Project	CMHA Meadows RAD Renovations	Addendum Number	2
Project Number	18076.04	Date	06/23/2026
To	All Bidders		
<i>This addendum contains changes to the requirements of the bidding Documents, Project Manual and Construction Drawings which have been issued to date. Such changes are to be incorporated into the Construction Documents and shall apply to the work in the same meaning and force as if they had been included in the original documents. Wherever this Addendum modifies a portion of a paragraph of the Project Manual or a portion of any Drawing, the remainder of the paragraph or Drawing shall remain in force.</i>			
Q&A	1. In regard to the new backflow preventer, is the water service currently routed correctly? The water lines are shown per record plan and correct to our knowledge. They are shown per the water service plan that was reviewed and approved through division of water.		
Specifications	REVISED UNIT PRICE on BID FORM. - DELETED UNIT PRICE #3 - ADDED UNIT PRICE #6 & 7. Section 01 21 13 Allowance - ADDED Section. Section 01 22 00 Unit Price - REMOVED Section 3.01 C. - ADDED Section 3.01 F and G. Section 06 16 00 Sheathing - ADDED Section Section 09 51 13 Acoustical Panel

4 PLAN SECOND FLOOR PLAN - UNIT 2-A - (BLDG. TYPES I, II, III, VI)
 1/4" = 1'-0"

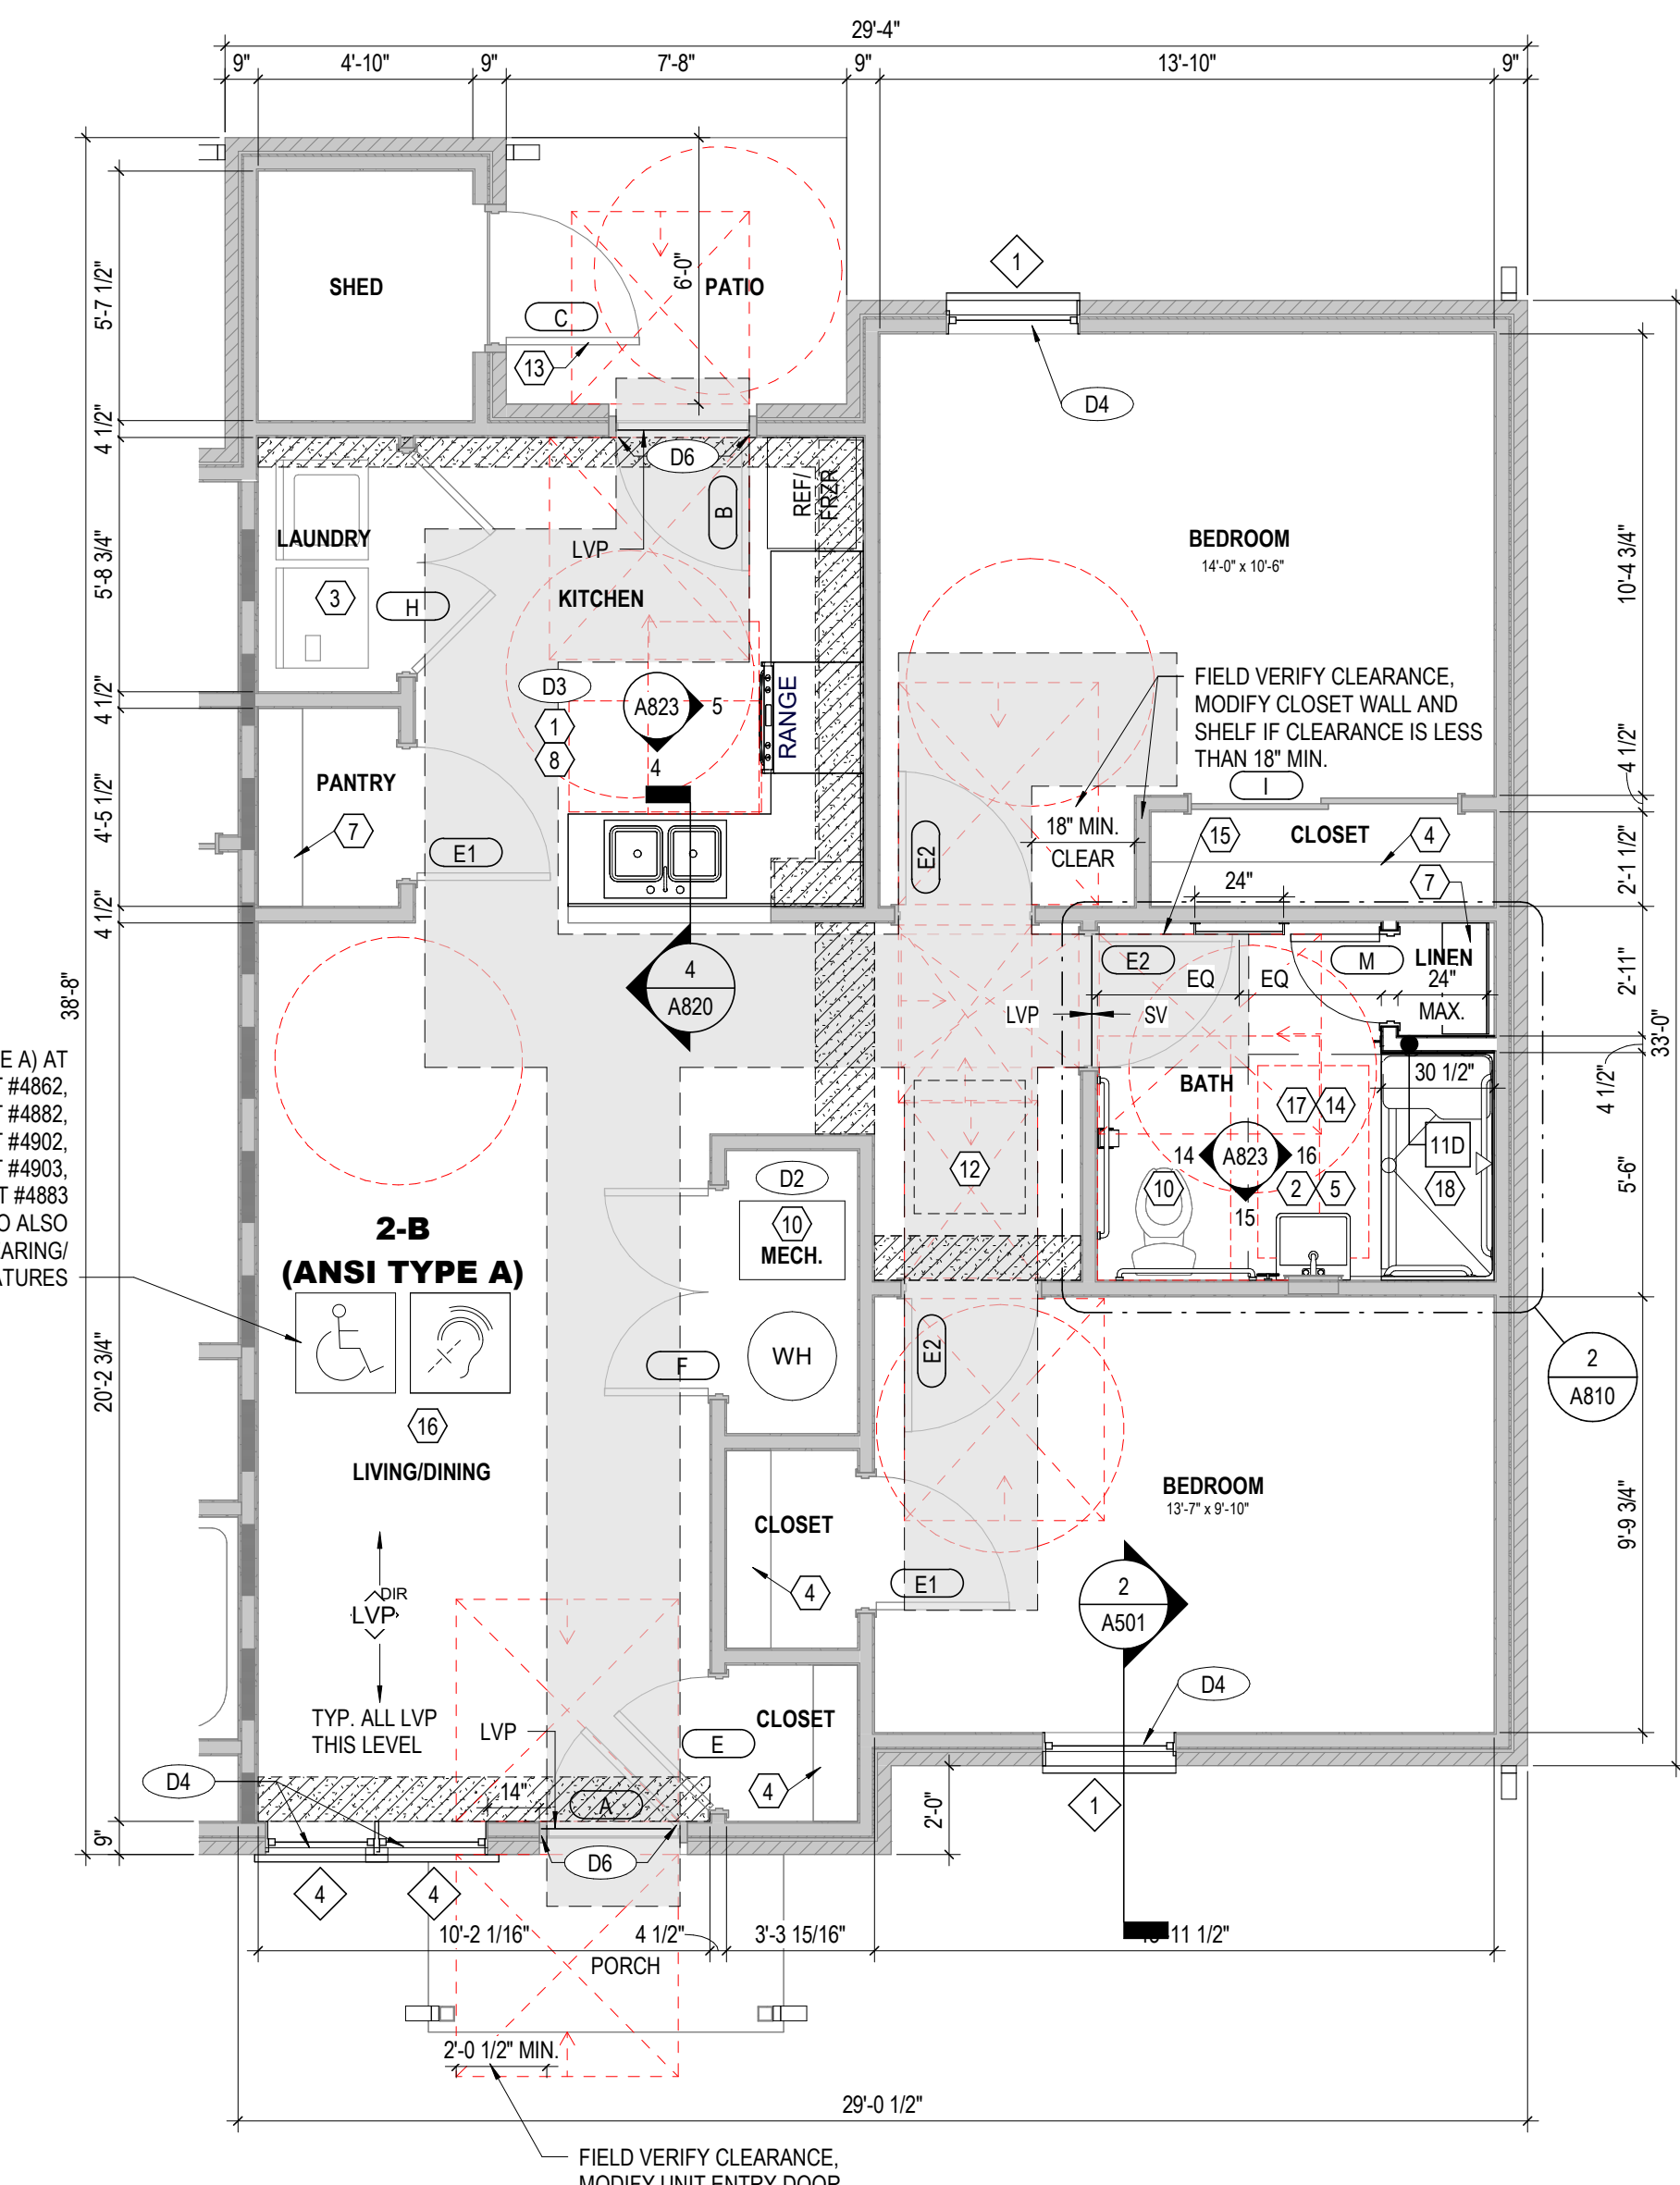
1. REVISED General Note I to “NOT USED”.
2. Under GENERAL NOTES – UNIT PLANS, ADDED TT. PROVIDE 1/4” THICK LUAN UNDERLAYMENT AT ALL AREAS IN ALL SECOND FLOOR UNITS.
3. REVISED GENERAL NOTES – UNIT PLANS P.
- a. EXISTING TUBS AND SURROUND TO REMAIN. **MIRRORED MEDICINE CABINETS TO BE REPLACED.** UNO. CLEAN ALL TUBS, SURROUND & RE-CAULK ALL JOINT, TYP.
4. REVISED Coded Note 5
- a. EXISTING MIRROR/MEDICINE CABINET TO BE **REMOVED & REPLACED** IN TYPICAL UNITS. **NEW MIRROR/MEDICINE CABINET IN ANSI TYPE A UNIT TO BE INSTALLED LOWER.** REFER TO TYPICAL PROJECT DETAILS FOR ADDITIONAL INFO.
5. Note applies to all Enlarged Plans (A810 through A811)

Sheet A823 – INTERIOR ELEVATIONS

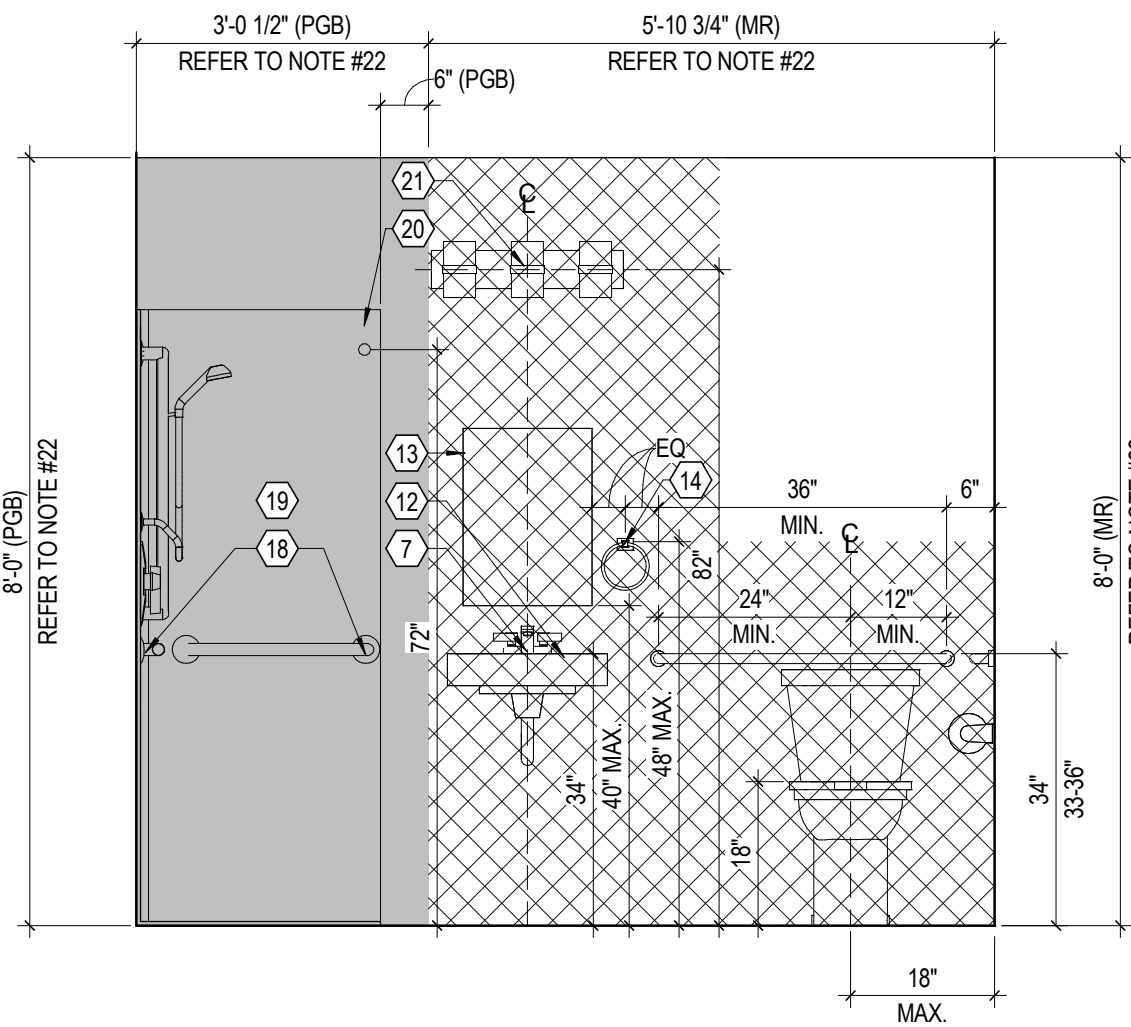
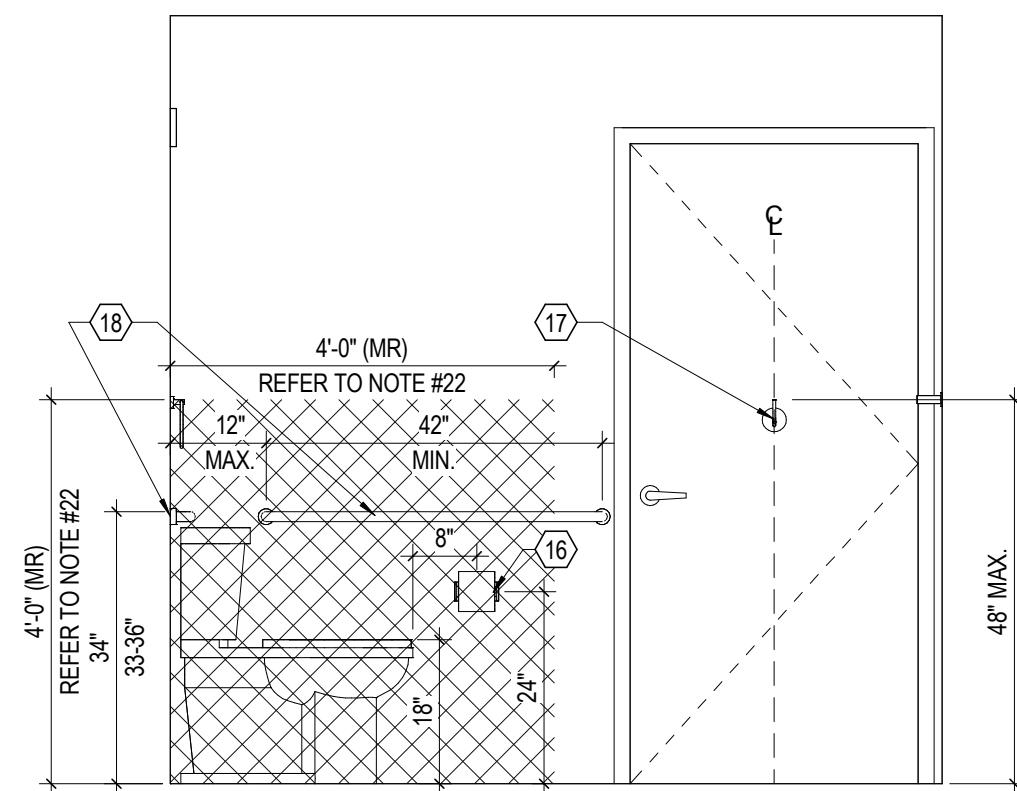
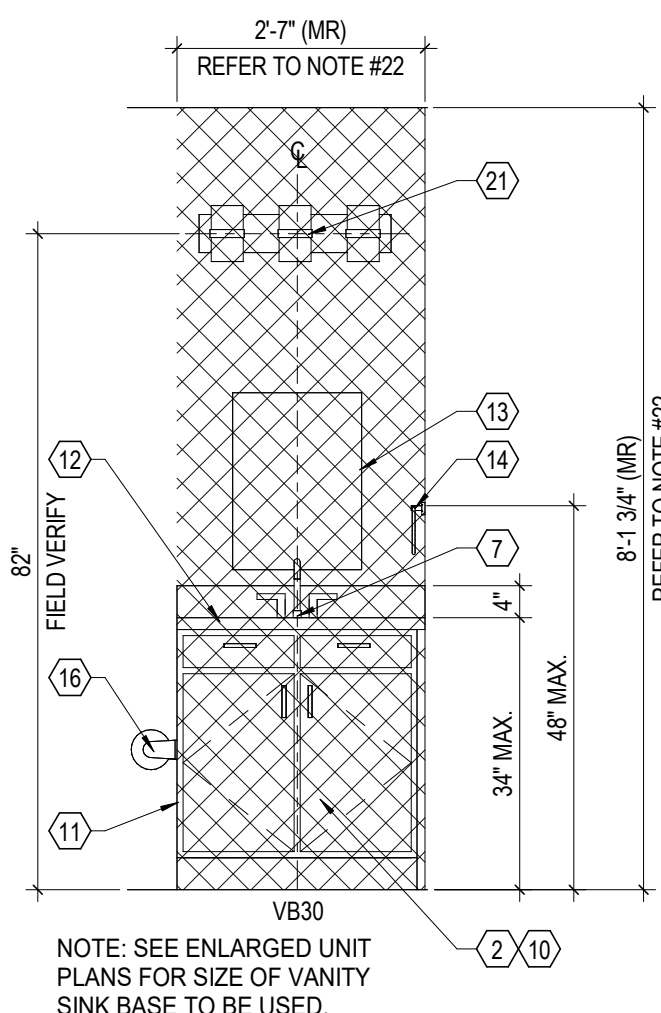
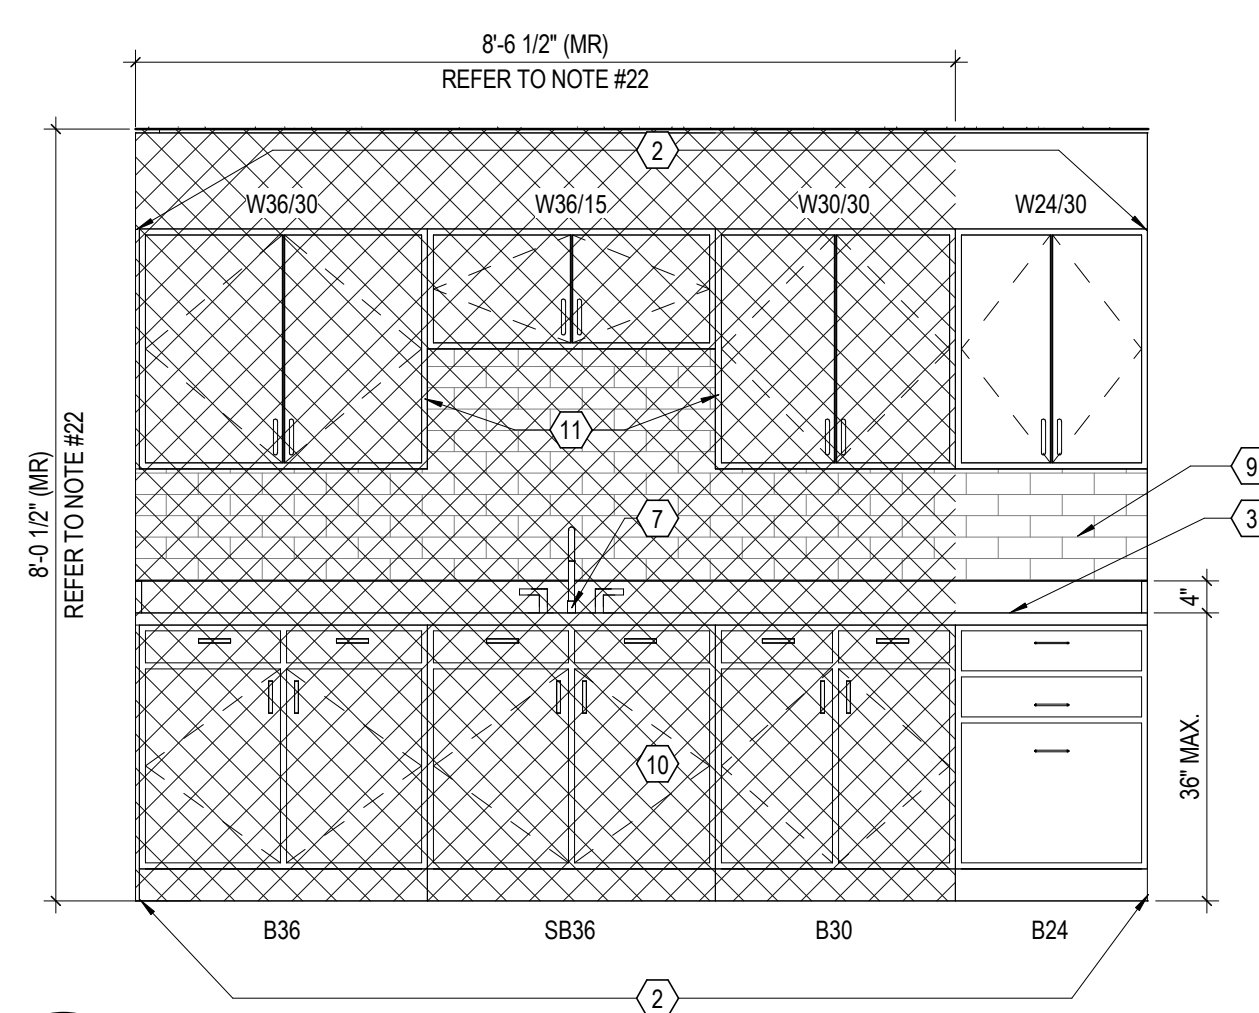
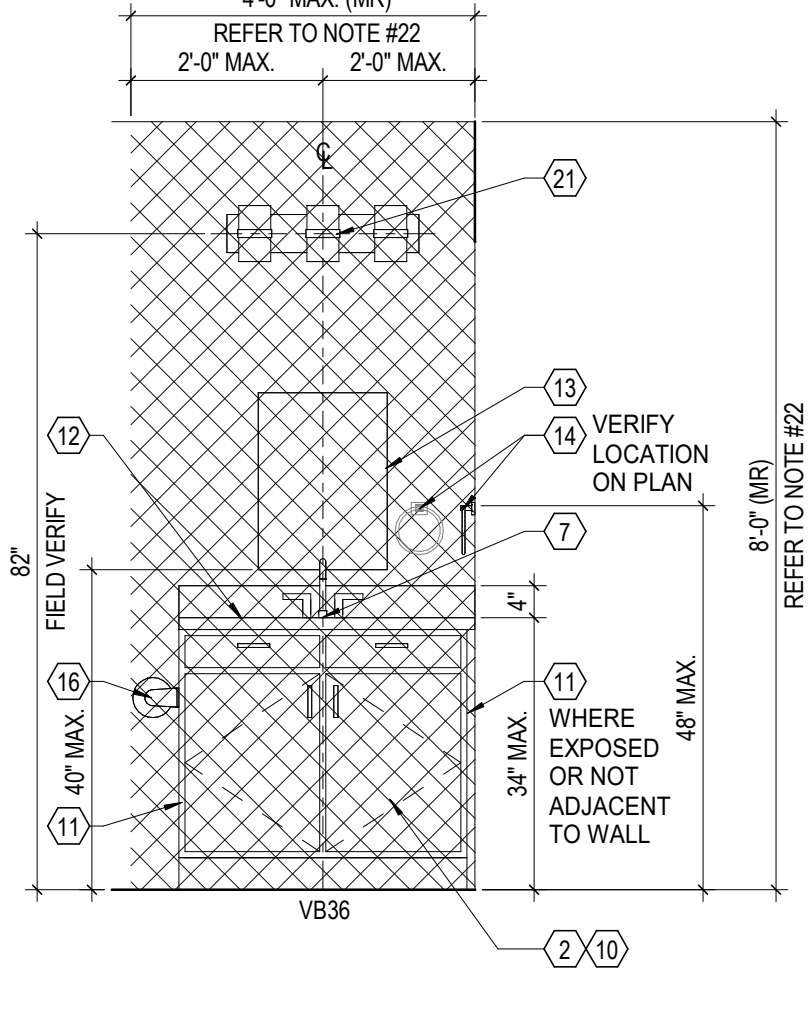
1. REVISED General Note 13.
- a. EXISTING MIRRORED MEDICINE CABINET TO BE **REMOVED & REPLACED** IN TYPICAL UNITS, CLEAN AND RECAULK. ANSI TYPE A UNIT: **NEW MIRRORED MEDICINE CABINET TO BE INSTALLED LOWER.** PATCH WALL AS REQUIRED.
